PARTS & SERVICE	REF NO.	AT01112
NEWS	DATE	Jul. 23, 2001
		Page 1 of 2

- **SUBJECT:** IMPROVED ENGINE COMPRESSOR PIPING MOUNTING BRACKET ON HD785-3, 5/HD985-3, 5
- **PURPOSE:** To introduce improved engine air compressor piping mounting bracket for use on HD785-3, HD785-5, HD985-3 and HD985-5 dump trucks
- APPLICATION: HD785-3 Dump Trucks, Serial Nos. 2001 thru 2574 HD785-5 Dump Trucks, Serial Nos. 4001 thru 4242 HD985-3 Dump Trucks, Serial Nos. 1001 thru 1020 HD985-5 Dump Trucks, Serial Nos. 1021 thru 1055
- FAILURE CODE: 832JHA

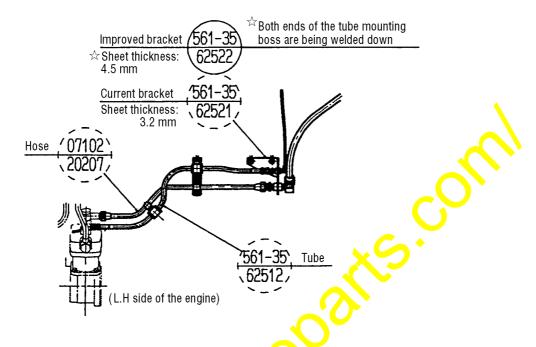
This Service News will introduce improved engine and compressor piping mounting bracket with increased durability for use on the 4D 785-3, HD785-5, HD985-3 and HD985-5 dump trucks.

Replace the current engine air compressor piping mounting bracket with the improved part.

(The items marked \ddagger are the contents of the improvement.)
